Access Compliance Report

Public Rights-of-Way

(Curb Ramps)

| Intersection ID: 44057 | Main Street: HOLLAND_PARK_LN | Cross Street: LONGSTONE_LN | Location: E |

| ADA ID: 6418020F2756 | Ramp Type: PerpDiag | Initial Pass/Fail: Fail | Overall Compliance: No |

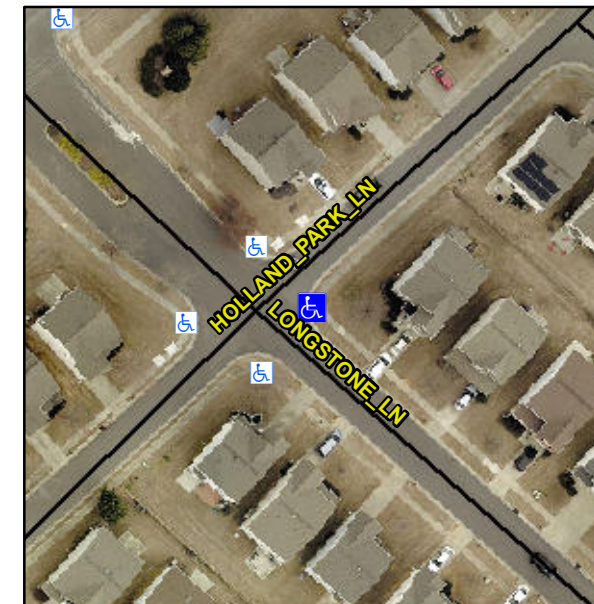
Not Found, R304.5.1, R304.5.3

| Compliance | Description | Data | Compliance | Description | Data |
|------------|-----------------------|-------|------------|-----------------------------|-------|
| N/A | Ramp Length (in) | 44.5 | Yes | Ramp Slope (%) | 5.5 |
| No | Ramp Width (in) | 37.5 | No | Ramp XSlope (%) | 11.5 |

Remove & Replace Curb Ramp With Two New Directional Ramps or Equivalent.
